Service Bulletin No. 401

<i>MODEL</i>	D / E / G / J Series	<i>TYPE</i>	Field Change Program	<i>SECTION/GROUP</i>	7-Electrical	<i>DATE</i>	Apr. 09, 2014
<i>SUBJECT</i>	SURE POWER BATTERY EQUALIZER						
<i>CONDITIONS</i>

Ref. Sure Power NHTSA Recall No.:13E-050

Figure 1.

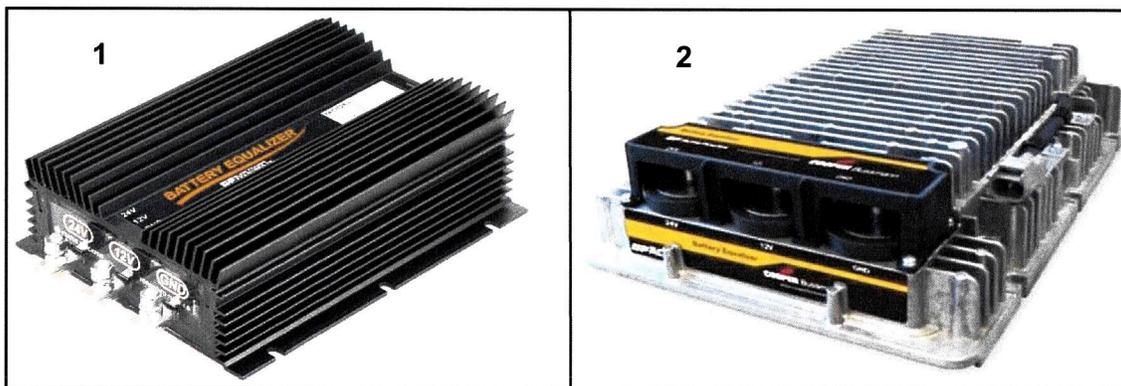
SHOWN IN FIGURE 1 ARE PHOTOGRAPHS OF THE EXISTING AND NEW MODELS OF BATTERY EQUALIZERS.

Item	Description
1	Existing potted equalizer. Part numbers 52208, 52210 or 52210RB
2	New cast equalizer. Part numbers 21080E00 or 21100E00

Figure 2. Fuse assembly hardware installation order.

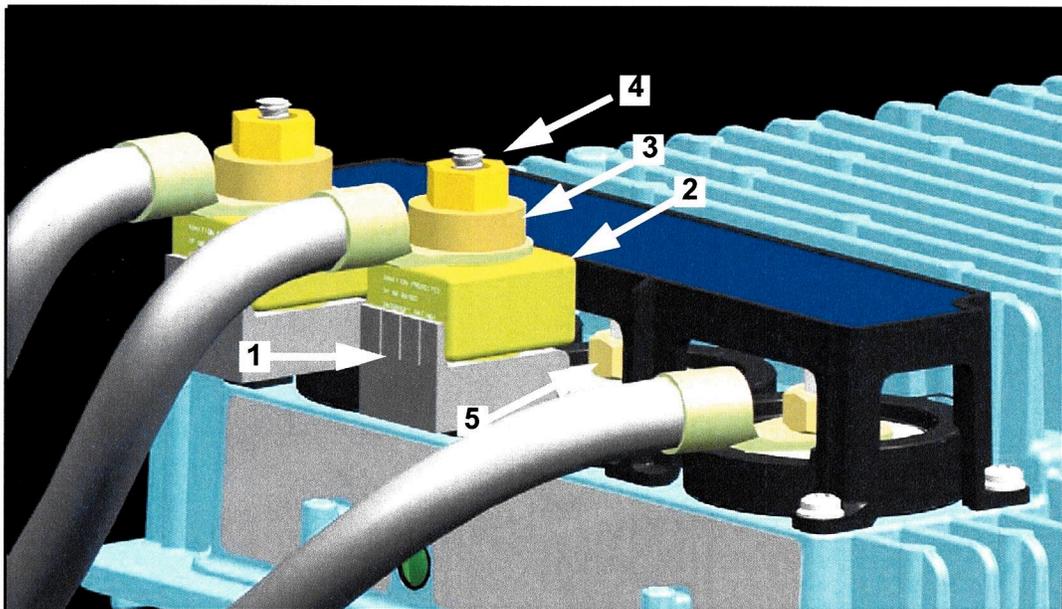
10. Install the new battery equalizer, p/n 07-09-1578 or 07-09-1585 (dependent on coach series), using the capscrew, p/n 19-1-385, lockwasher, p/n 19-2-37, flat washer, p/n 19-2-23 and nut, p/n 19-3-32. Torque capscrew to 73-77 in-lbs.
11. Ensure that the battery equalizer is stable in position.
12. Remove and retain the nut from the 12V stud on the battery equalizer. Orient and install the busbar, p/n 07-08-3314. Secure the busbar to the equalizer using the existing nut.
13. Orient and install the fuse, p/n 07-08-3317 or 07-08-4033 (dependent on coach series), on the busbar stud (refer to Figure 2).
14. Orient and install the ring terminal and secure with the insulated nut, p/n 07-08-3373. Torque nut to 100-110 in-lbs.
15. Repeat Steps 12 to 14 to the 24V stud.

Item	Description
1	Busbar
2	Fuse
3	Ring terminal with wire
4	Insulated nut
5	Battery equalizer nut
